PLANNING AND DEVELOPMENT SERVICES STAFF REPORT

For Planning Commission Meeting of May 21, 2013

**SUBJECT: 414 Main Rezoning and Site Plan
Project Nos. Z13-004 and SP13-008**

**401 N. Fourth Avenue Rezoning and Site Plan
Project Nos. Z13-005 and SP13-009**

Issued for:
 Preliminary
 1/9/13
 City of Ann Arbor
 Design Review Board
 1/29/13
 City of Ann Arbor
 Planning Commission
 3/25/13
 Bid Set
 Construction

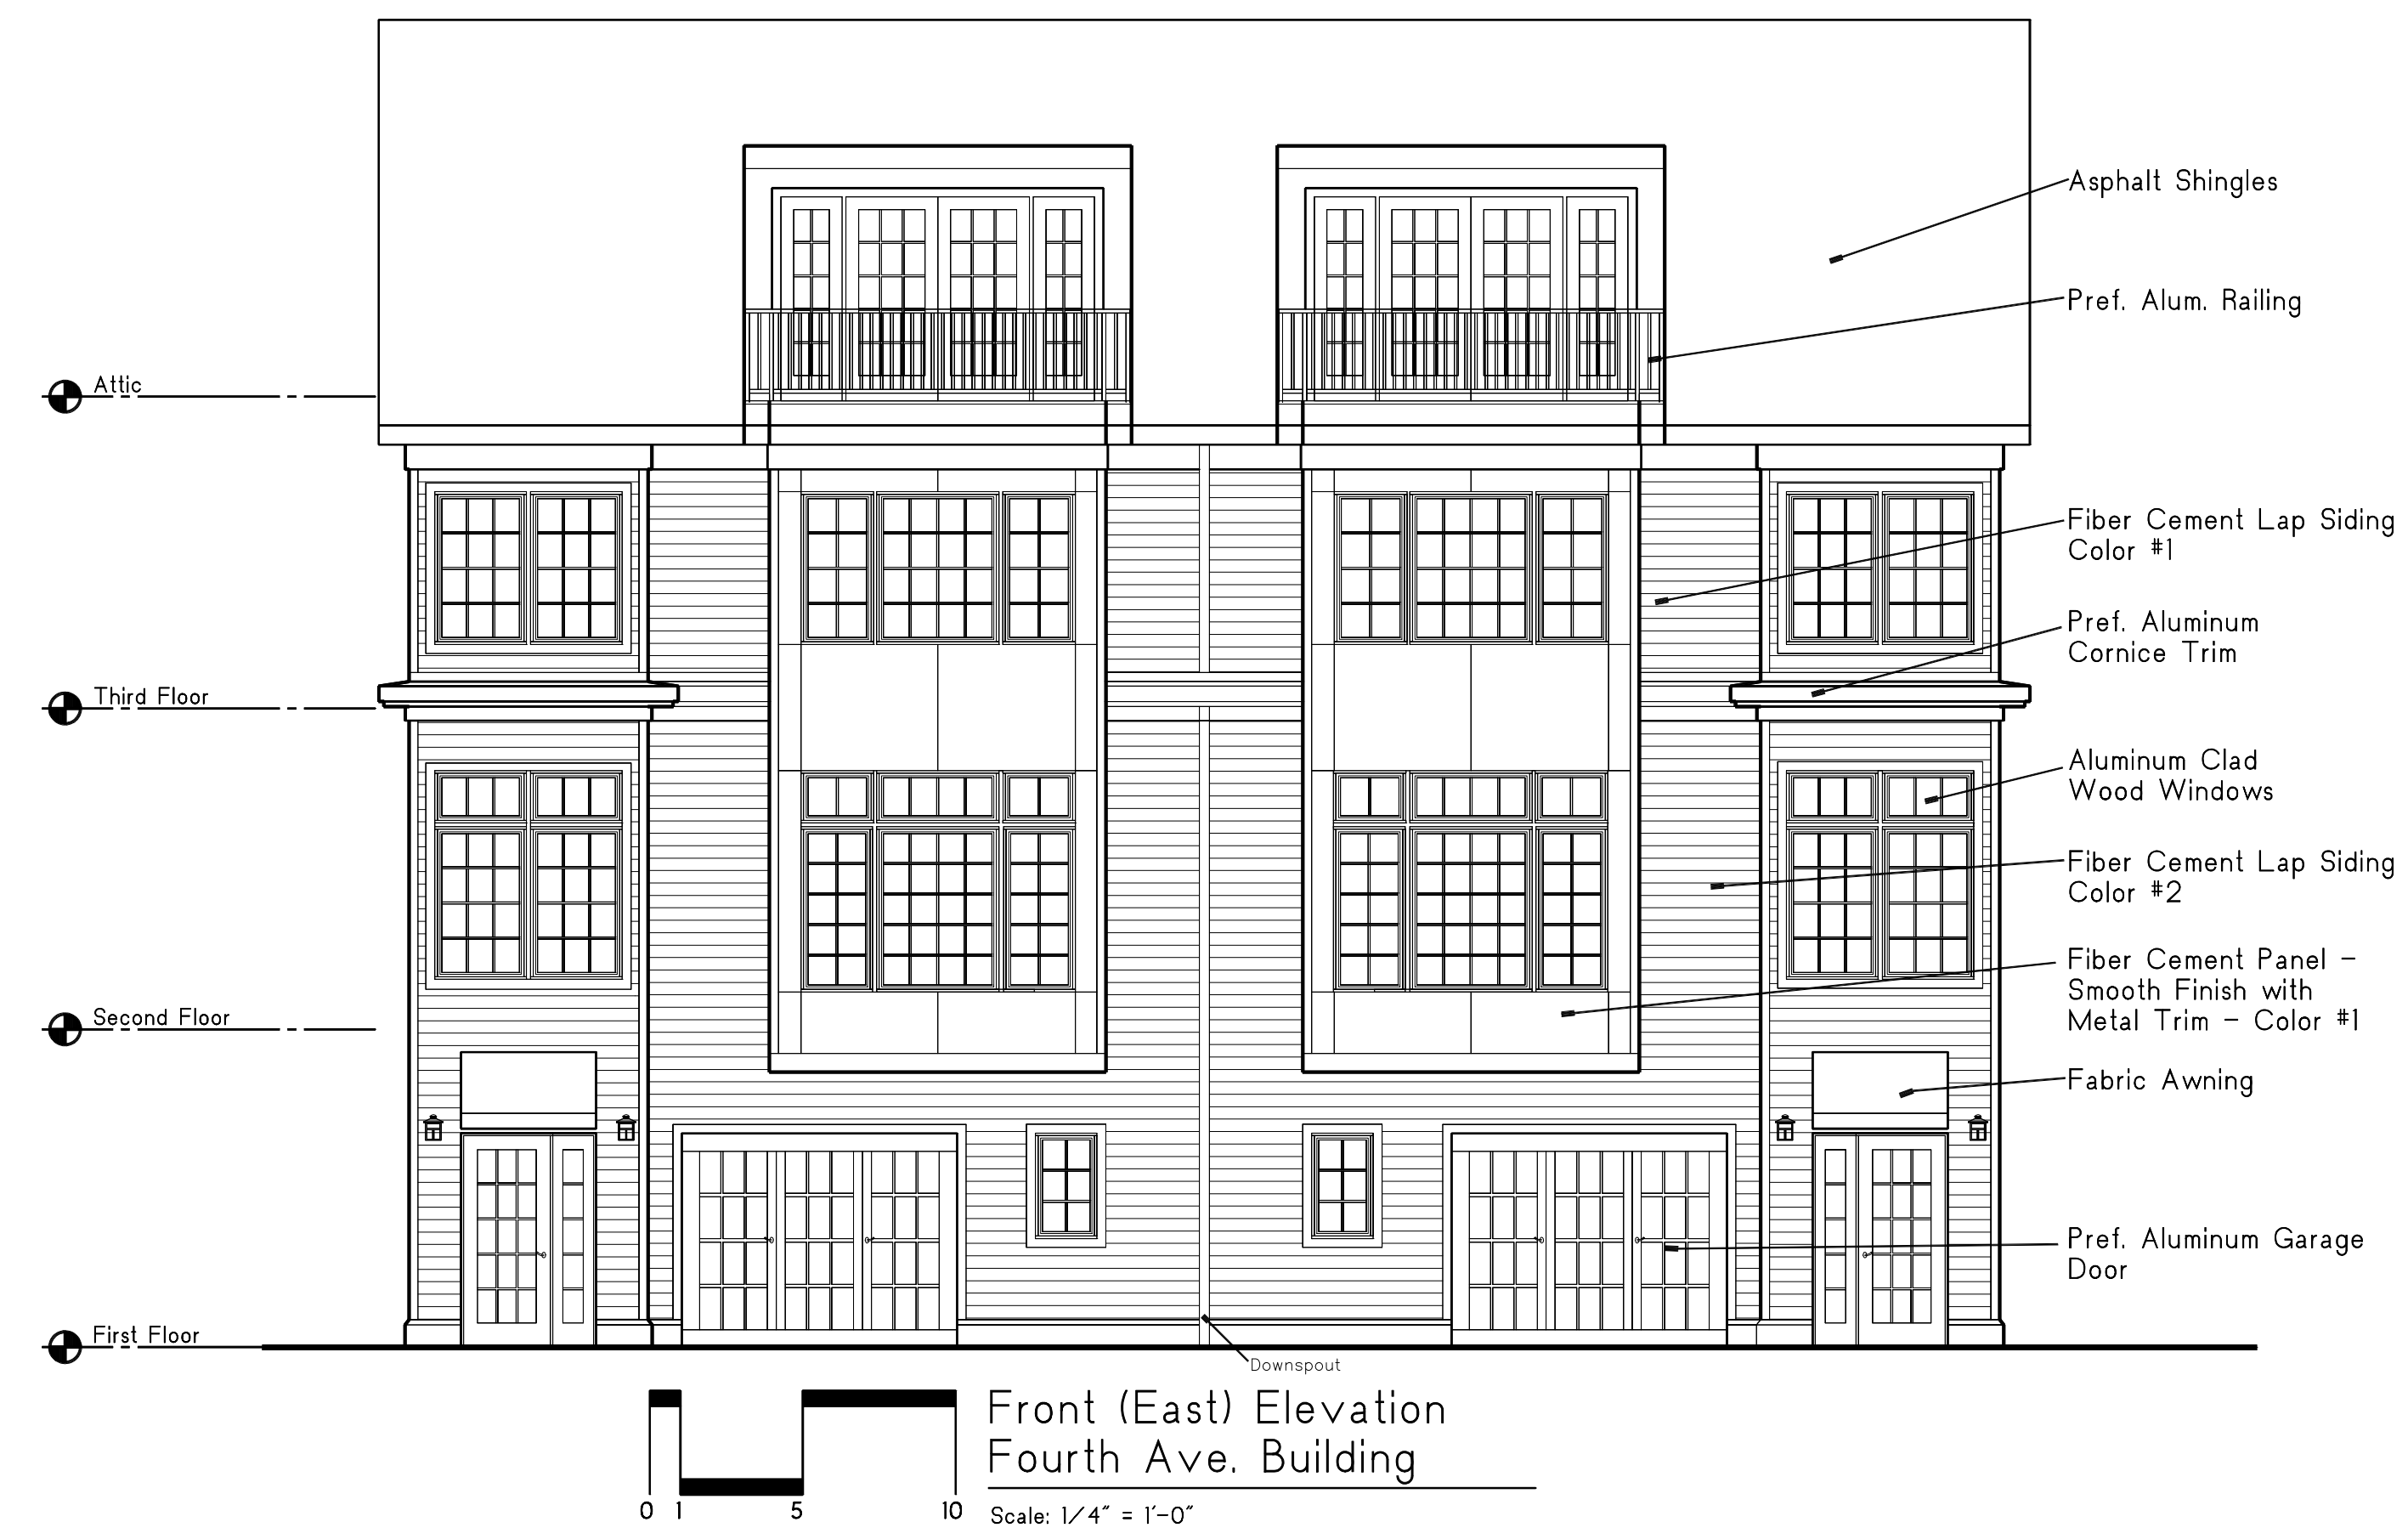
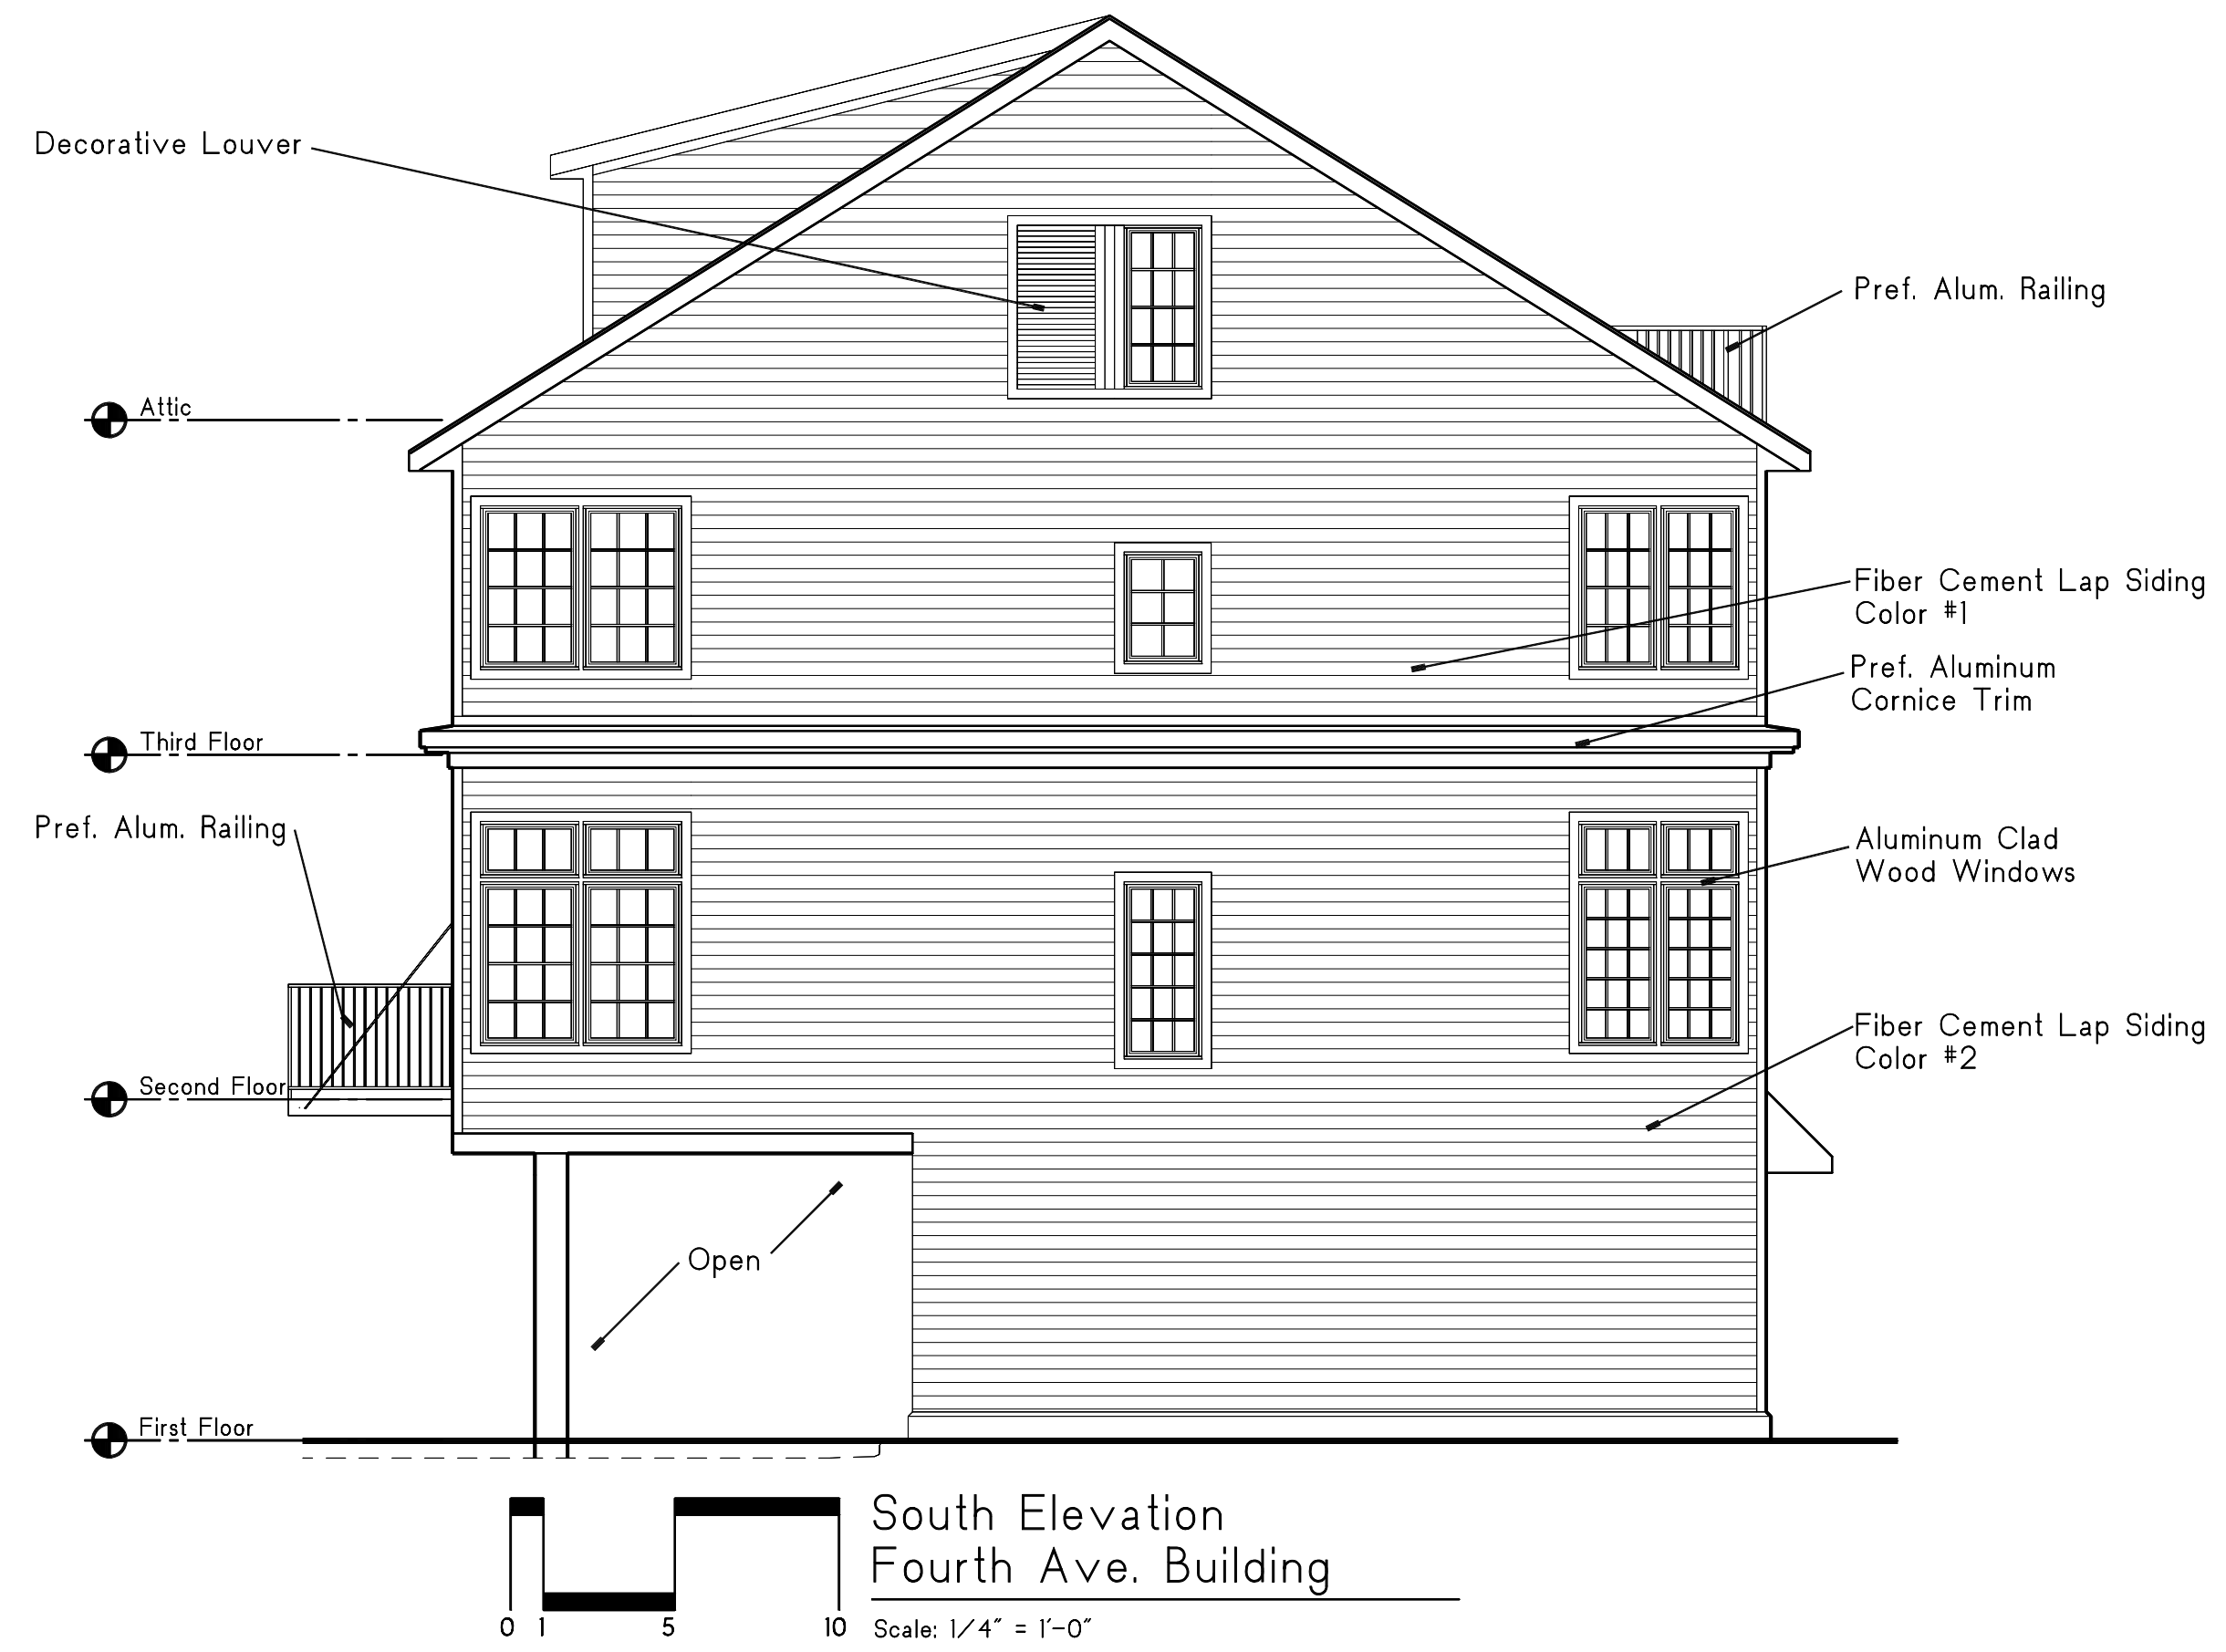
Second, regarding the Fourth Ave building, the two double-wide garage doors dominate the street level façade. The Fourth Ave garage doors were cited as the one glaring deviation from the intent of the design guidelines and the Board felt the doors were no better than a surface parking lot. The garage doors overwhelm the existence of the pedestrian front doors to each unit. The design team explained there was not enough lot width to accommodate a double-loaded parking lot and two double-garage doors at the rear of the building. The design team also noted that if the garage doors were relocated to the rear of the building, the Fourth Avenue street level façade would still not have active uses. The Board felt that a blank wall with landscaping between the building and sidewalk would be an improvement and better achieve the intent of the design guidelines.

Two double garage doors on the east side of the building have been replaced with two single garage doors on the east side and two single garage doors on the west side as recommended by the DRB. Additional landscaping has been added to the east side of the building.
